# Access Compliance Report

## Public Rights-of-Way

### (Curb Ramps)

Intersection ID: 4889	Main Street: CELOSIA_DR	Cross Street: PAVILION_BV	Location: NE
ADA ID: 63023C7DCDAA	Ramp Type: Perp	Initial Pass/Fail: Fail	Overall Compliance: No
Severity Score: 33.75			
Codes/Mitigation Info/Possible Solution		Field Measurements/Component Compliance

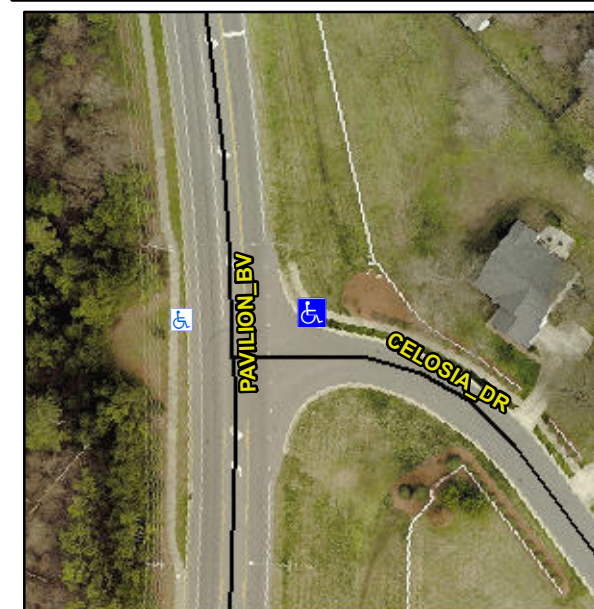
**R304.5.1, R304.2.2**

Compliance	Description	Data	Compliance	Description	Data
N/A	Ramp Length (in)	96.0	No	Ramp Slope (%)	13.0
No	Ramp Width (in)	43.0	Yes	Ramp XSlope (%)	1.7
N/A	Flare Type LT	N/A	N/A	Flare Type RT	N/A
N/A	Flare Slope LT (%)	N/A	N/A	Flare Slope RT (%)	N/A
N/A	Flare Traversable LT?	N/A	N/A	Flare Traversable RT?	N/A
N/A	Landing Length (in)	N/A	N/A	DWS Provided?	N/A
N/A	Landing Width (in)	N/A	N/A	DWS Contrast?	N/A
N/A	Landing Slope (%)	N/A	N/A	DWS Length (in)	N/A
N/A	Landing X Slope (%)	N/A	N/A	DWS Full Width?	N/A
N/A	Landing Curb? (Y/N)	N/A	N/A	DWS Offset (in)	N/A
N/A	Shared Landing?	N/A			
N/A	Gutter Ponding?	N/A	N/A	Gutter Slope (%)	N/A
N/A	Gutter Lip Ht (in)	N/A	N/A	Gutter X Slope (%)	N/A
N/A	Painted X Walk1?	No	N/A	Painted X Walk2?	N/A
	X Walk 1 Direction	To W		X Walk 2 Direction	N/A
N/A	X Walk 1 Width (in)	N/A	N/A	X Walk 2 Width (in)	N/A
	X Walk 1 Slope (%)	6.8		X Walk 2 Slope (%)	N/A
	X Walk 1 X Slope (%)	1.3		X Walk 2 X Slope (%)	N/A

**Remove & Replace Entire Ramp.**
